RE: Revision of second floor support system above garage for Lot #20 Hawthorne Ridge – 3020 SW Arboridge Dr. Lee's Summit, MO 64082 - Permit # PRRES20193631.

This letter addresses the revision of second floor support system above the garage.

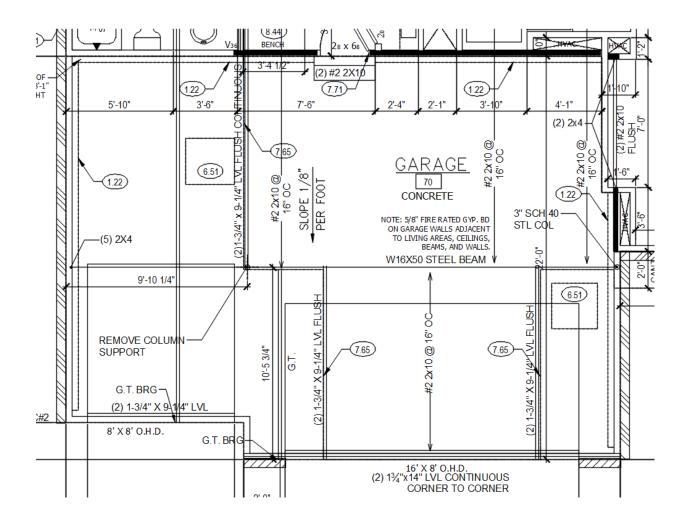
- Appropriate temporary supports shall be installed before the removal of the existing beam to ensure the structure is stable during beam replacement.
- Remove existing W16x26 steel beam spanning approximately 20'.
- Remove existing column support as shown below.
- Install new W16x50 A992 steel beam spanning approximately 30'-2".
- End supports for new W16x50 steel beam shall be as shown below; (5) 2x4 Douglas Fir Larch #2 at support by 8' garage door opening and 3" Sch 40 Steel Column at support wall by dining room.
